## **Urgent: Medical Device Correction**

### **NOVA MONARCH ROLLATOR MODEL 4329**

**Models:** 4329BL, 4329PL and 4329RD.

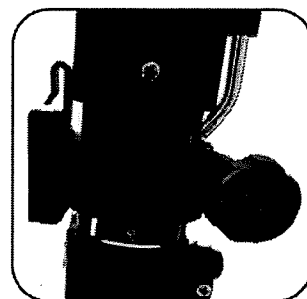
To address this issue on current and future units, we have created an improved backrest holder that has a lip to prevent the backrest from disengaging from the unit.

New backrest holders will be sent to attach to your unit.  
(Replacement part #HCT-432915)

4. Slide the backrest holder up the handle to the desired height and then turn the knob to secure into place.

5. Ensure the knob is facing the outside of the unit.
